CEC1: 'Comment on gmd-2021-304', Astrid Kerkweg, 03 Nov 2021

RC1: 'Comment on gmd-2021-304', Anonymous Referee #1, 11 Nov 2021

RC2: 'Comment on gmd-2021-304', Anonymous Referee #2, 23 Dec 2021

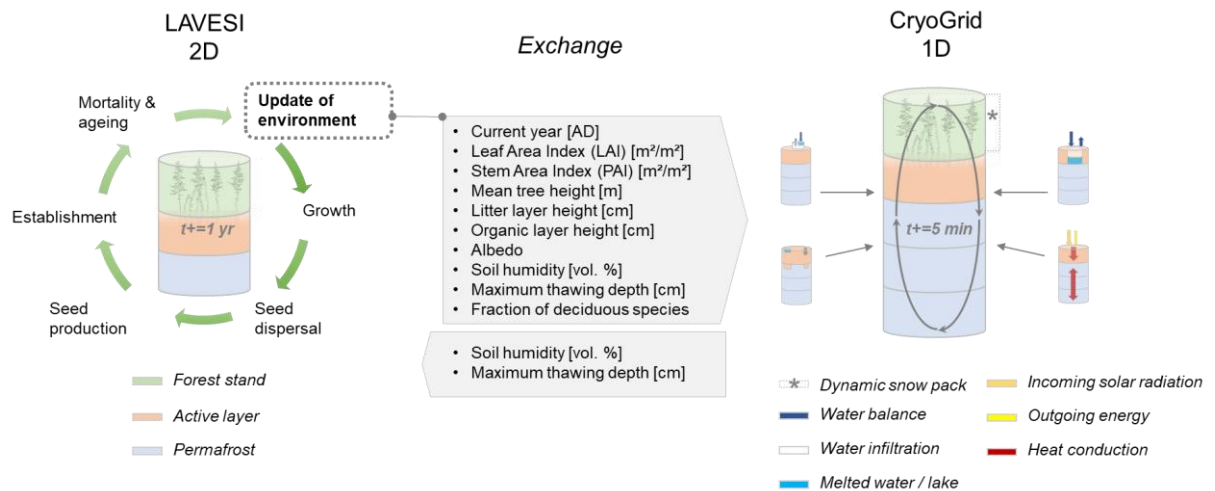
Nevertheless, it might be worthwhile to start the Methods section with a short characterization of both models, for LaVESI including the original one and the revised one. One way to do so could be filling in a Table for both models with the information required by the Overview part of the ODD protocol for describing models. This would allow readers who are less interested in technical details, at least upon first reading, to get a complete overview of the scales, entities, state variables, and processes included in both models. A detailed description of the scheduling of the combined models process would also be helpful, to better see via which variables both models interact, and how the different temporal resolutions were dealt with. (If all this is described in the Supplement, please refer to the Supplement more explicitly, and more specifically).

Response: *Following the reviewer's comment, we added a new table in Appendix A as suggested to present the changes from the initial version to the current version presented in this study. In the main text, we included the ODD protocol "Overview" part in the model descriptions and added the suggested short description at the beginning of the methods section.*

This paragraph is added as follows: *"We further developed two models and start each description by using the Overview part of the ODD protocol for describing individual based models (Grimm et al, 2010). We describe the host model LAVESI in section 2.1, a spatially-explicit, individual-based model handling the full life-cycle of tree species and interactions among individuals and its environment. The second model CryoGrid, which is informed by the host model and delivers improved state variables back to LAVESI, is described in section 2.2, a one-dimensional, numerical land surface model that simulates the thermo-hydrological regime of permafrost ground by numerically solving the heat-conduction equation."*

The second part of the comment about different scales and interaction between models. We described in section 2.3 Coupling the relevant items. For a clarification of the interaction and the scheduling of the two coupled models we improved Fig. 2.

The figure was changed to:
